Access Compliance Report

Public Rights-of-Way

(Curb Ramps)

Intersection ID: 26209	Main Street: CARMEL_RD	Cross Street: JOHNSTON_RD	Location: SE
ADA ID: C9101FD63859	Ramp Type: Perp	Initial Pass/Fail: Fail	Overall Compliance: No
Severity Score: 8.75			
Codes/Mitigation Info/Possible Solution		Field Measurements/Component Compliance

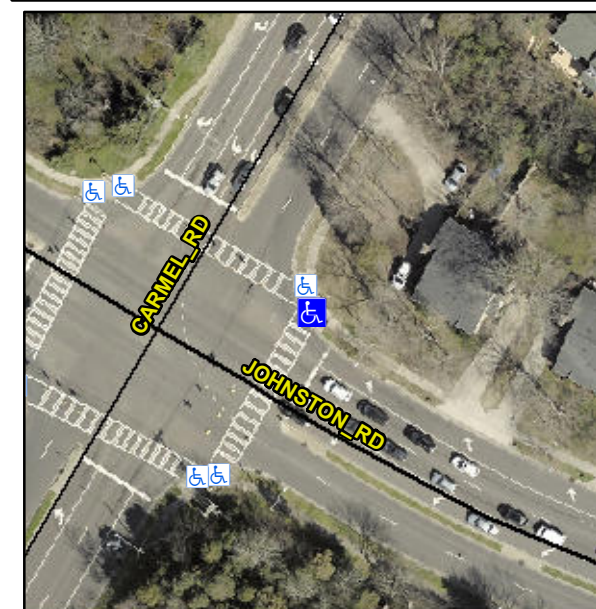
R304.5.1

Compliance	Description	Data	Compliance	Description	Data
N/A	Ramp Length (in)	60.0	Yes	Ramp Slope (%)	7.5
No	Ramp Width (in)	45.5	Yes	Ramp XSlope (%)	1.8
N/A	Flare Type LT	N/A	N/A	Flare Type RT	N/A
N/A	Flare Slope LT (%)	N/A	N/A	Flare Slope RT (%)	N/A
N/A	Flare Traversable LT?	N/A	N/A	Flare Traversable RT?	N/A
N/A	Landing Length (in)	N/A	N/A	DWS Provided?	N/A
N/A	Landing Width (in)	N/A	N/A	DWS Contrast?	N/A
N/A	Landing Slope (%)	N/A	N/A	DWS Length (in)	N/A
N/A	Landing X Slope (%)	N/A	N/A	DWS Full Width?	N/A
N/A	Landing Curb? (Y/N)	N/A	N/A	DWS Offset (in)	N/A
N/A	Shared Landing?	N/A			
N/A	Gutter Ponding?	N/A	N/A	Gutter Slope (%)	N/A
N/A	Gutter Lip Ht (in)	N/A	N/A	Gutter X Slope (%)	N/A
N/A	Painted X Walk1?	Yes	N/A	Painted X Walk2?	N/A
	X Walk 1 Direction	To SW		X Walk 2 Direction	N/A
N/A	X Walk 1 Width (in)	135.0	N/A	X Walk 2 Width (in)	N/A
	X Walk 1 Slope (%)	3.1		X Walk 2 Slope (%)	N/A
	X Walk 1 X Slope (%)	3.4		X Walk 2 X Slope (%)	N/A

Remove & Replace Entire Ramp.
